A12 Chelmsford to A120 DCO Review

Alternative De-trunking Proposals

Technical Note

March 2023

FEERING TO MARKS TEY NATIONAL HIGHWAYS PROPOSALS SHEET 1 OF 2

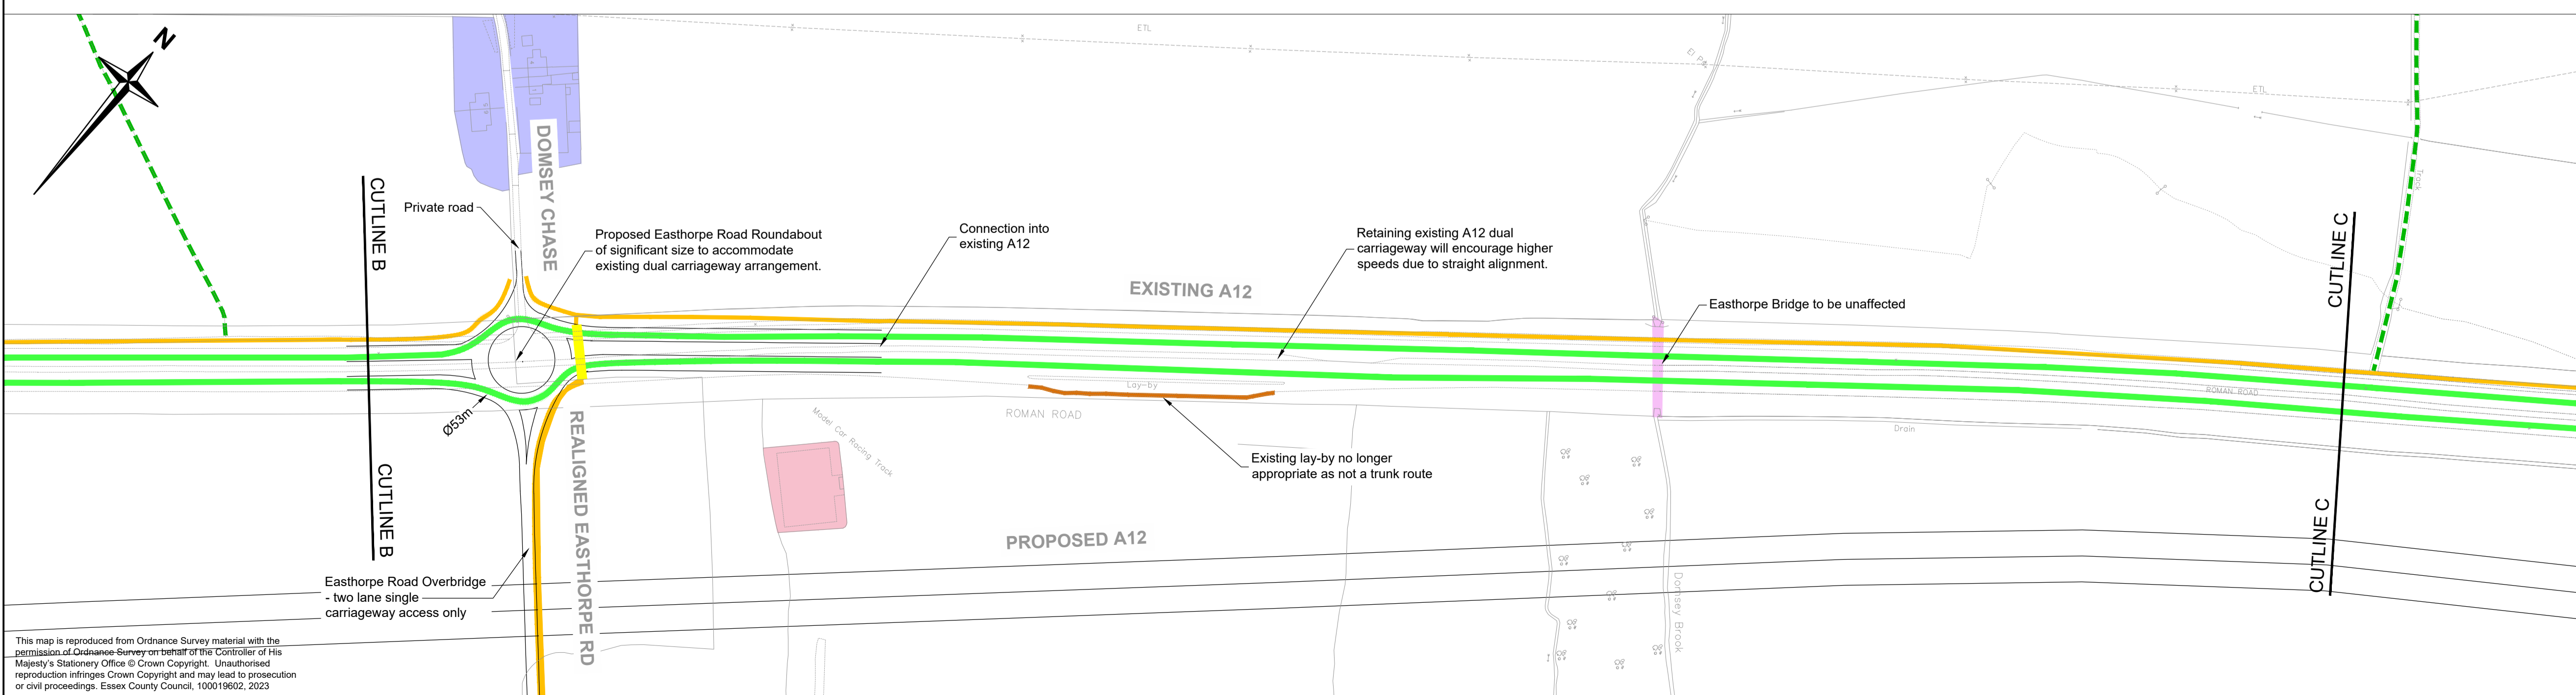
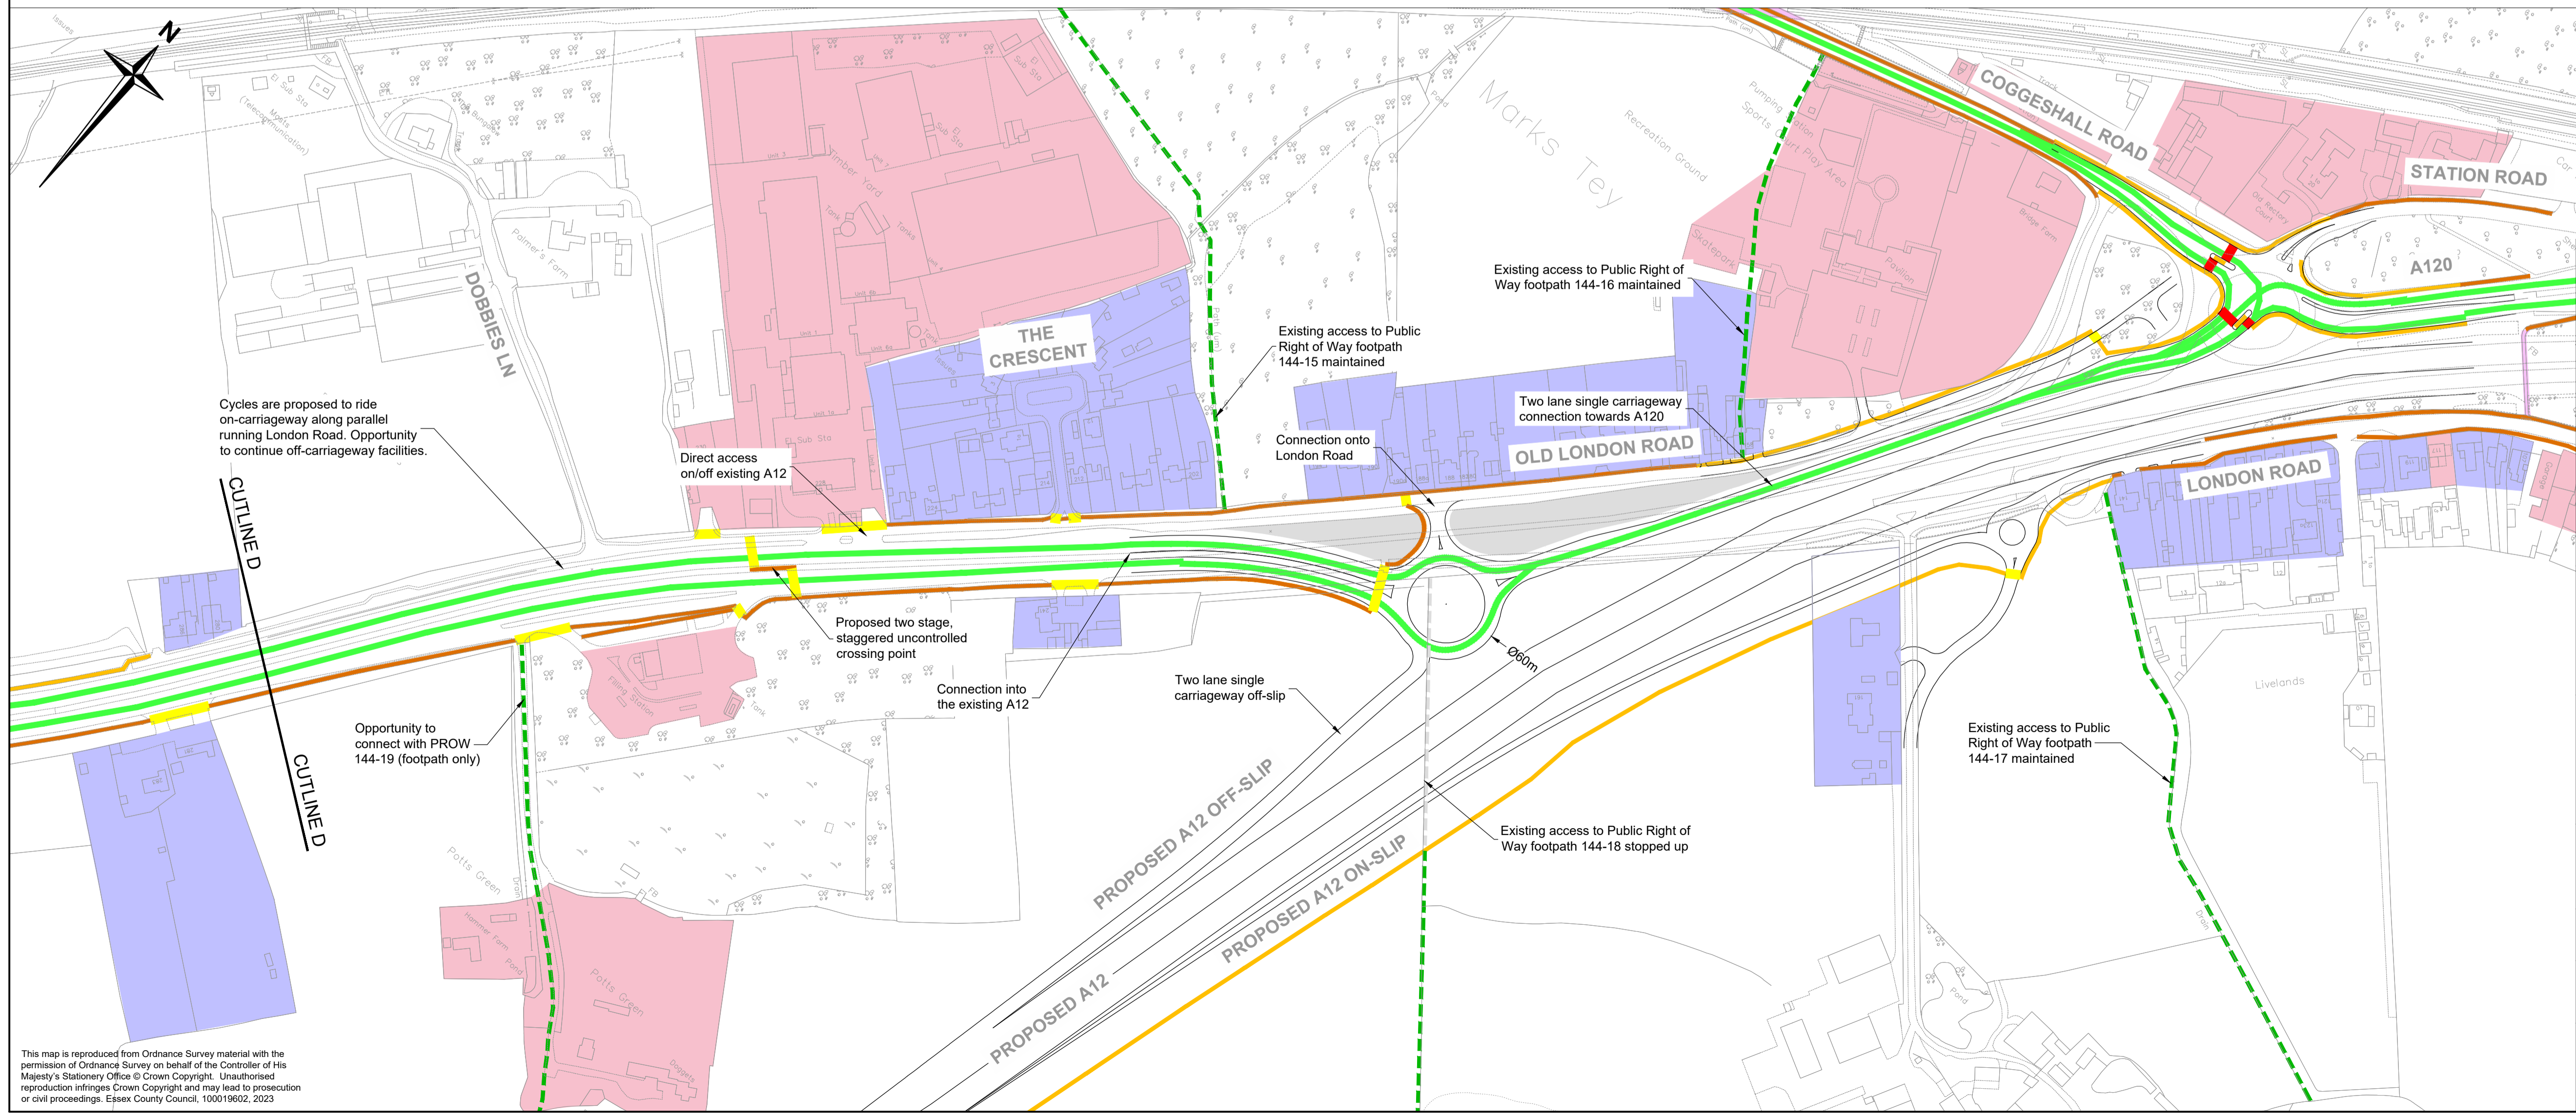
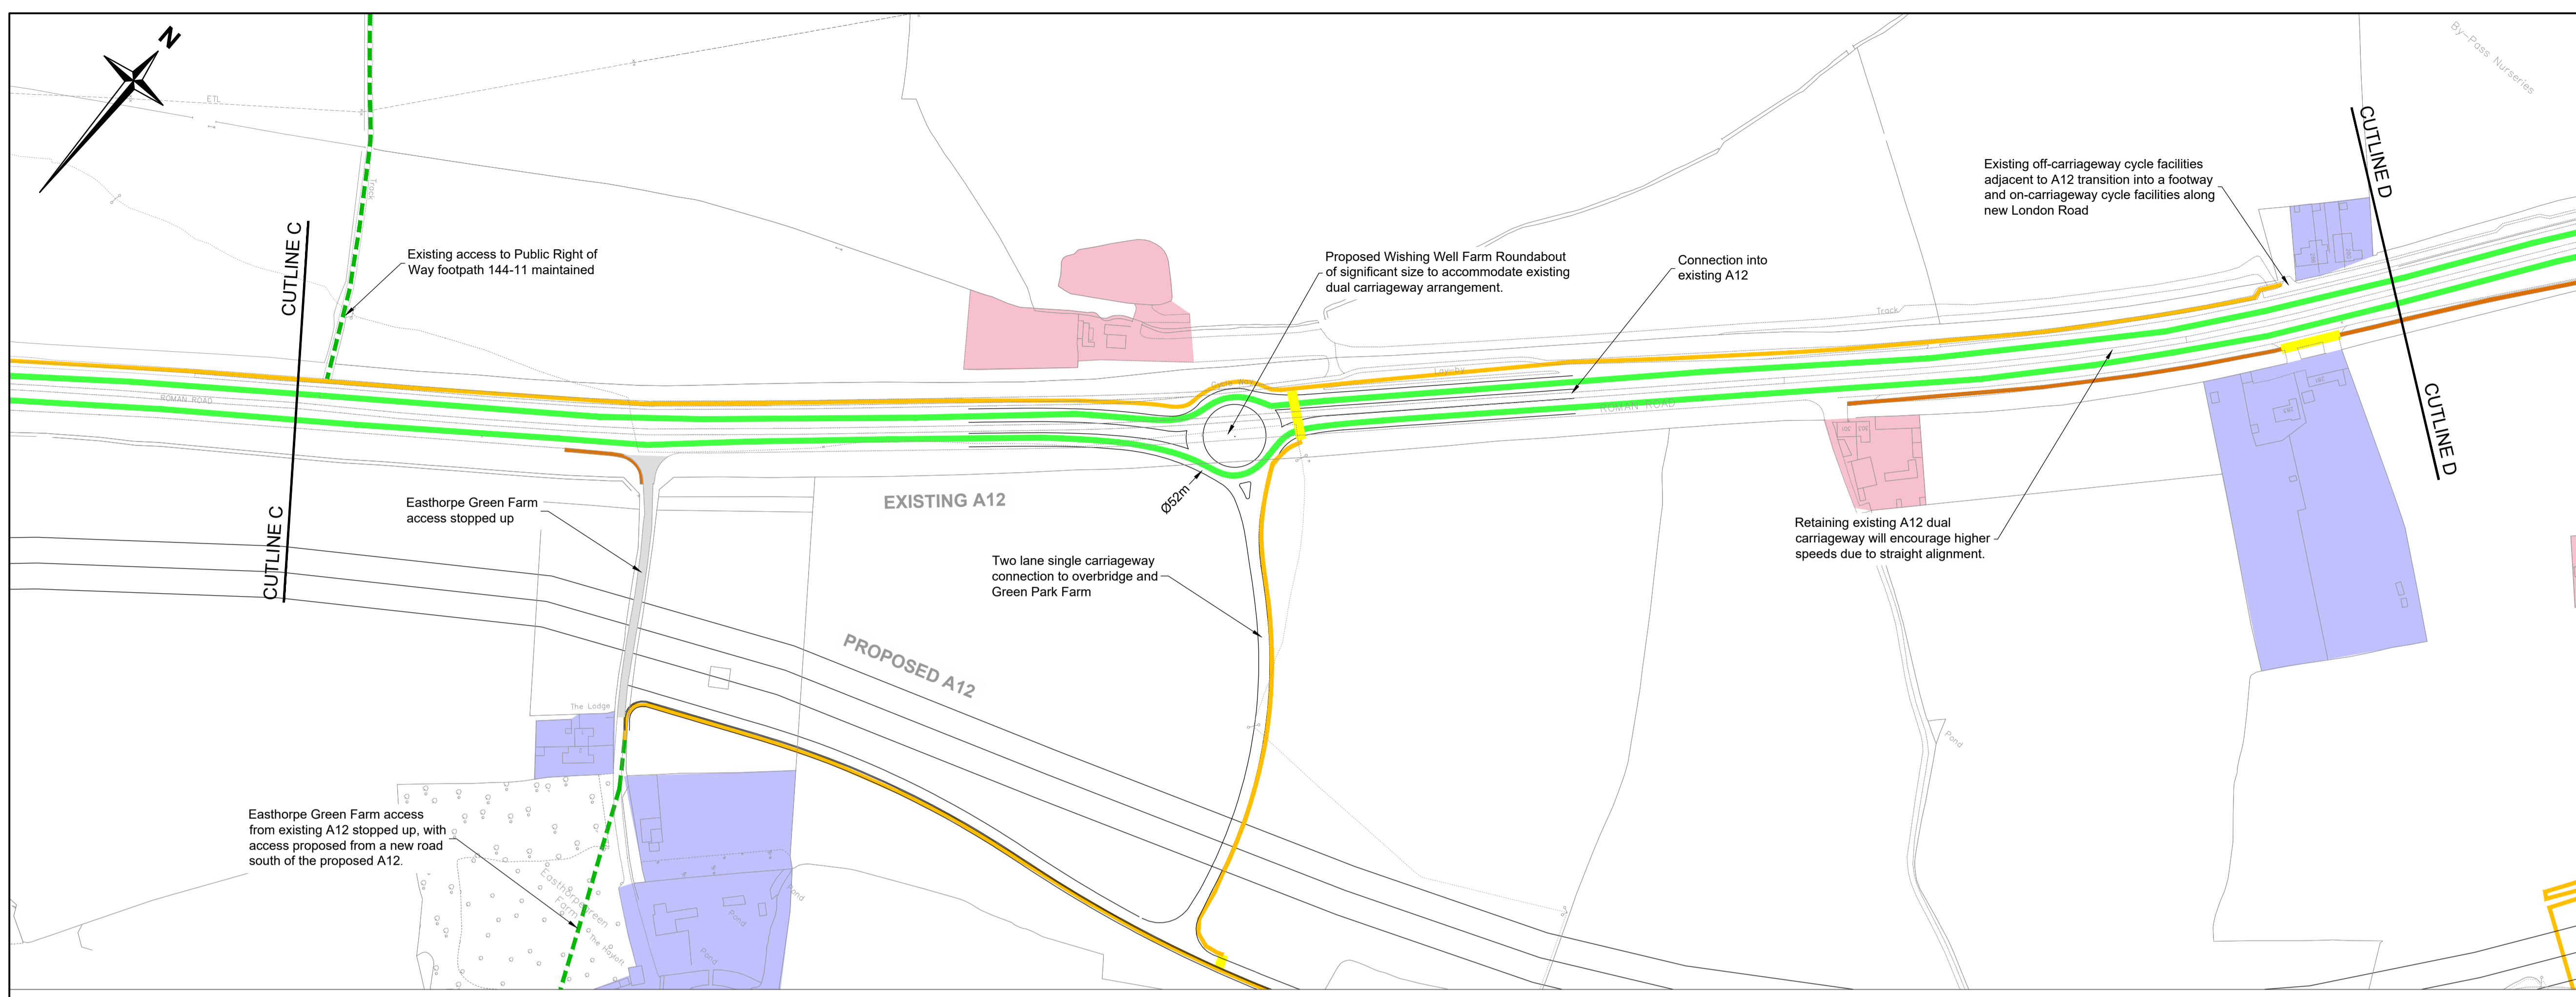
- The selection of a sizeable roundabout for the proposed Wishing Well Farm Roundabout (facilitating access to an overbridge over the proposed A12 alignment to Green Park Farm) is due to accommodating the existing dual carriageway arrangement, with a roundabout of this size a significant overprovision when considering the requirements of the minor arm. This is reinforced by NH’ decision to only provide a priority junction south of the overbridge, when interfacing the common minor arm with a single carriageway road.

These junctions are proposed by NH along the de-trunked section of the A12 to provide access to minor roads and farms (with associated low flows). With ECC proposing to reduce the existing A12 to a single carriageway, a roundabout is not needed and a simple priority junction or crossroad arrangement would be sufficient.

Using the above results, has instead proposed a simple priority junction to replace the Wishing Well Farm Roundabout, and a crossroads made up of two simple priority junctions to replace the Easthorpe Road Roundabout.
